PARTS & SERVICE NEWS

REF NO.	AA99069
DATE	March 23, 1999

SUBJECT: INTRODUCTION OF ONE PIECE WRIST REST ADJUSTMENT BAR

APPLICATION: WA320-3mc Wheel Loaders, S/N A31056
WA380-3mc Wheel Loaders, S/N A51038
WA420-3mc Wheel Loaders, S/N A31014
WA450-3mc Wheel Loaders, S/N A31013 and A35001

Figure 2

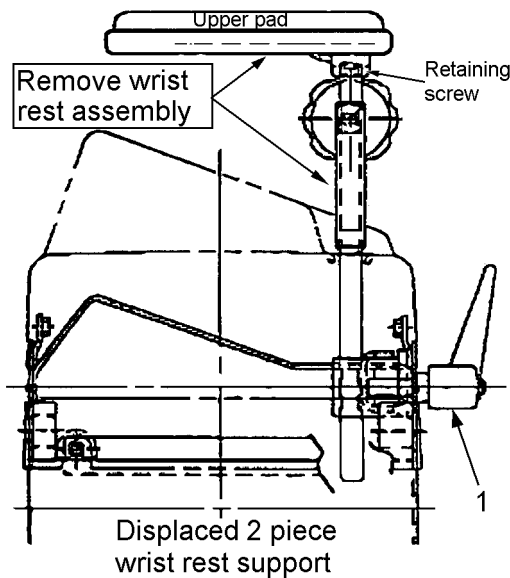
A new one-piece wrist rest support bar is released to ease the wrist rest adjustment process for the operator. Follow instructions in this **PARTS & SERVICE NEWS** to remove the displaced two-piece bar, Figure 1 and instal the new one-piece bar.

1. Loosen the lower adjustment lock handle, 1-figure 2. Lift the complete wrist rest and support assembly from the right console.

2. Remove the upper pad attach bolt. Retain the pad and bolt and discard the remaining parts. They are no longer required. Refer to Figure 2.
3. Assemble the previously removed pad to the new support bar, 421-54-23420. Use the old bolt.
4. Slip the new wrist rest support bar through the yoke assembly in the right console, set the correct height and tighten the lower adjustment lock handle to secure the wrist rest in that position. Refer to Figure 3.
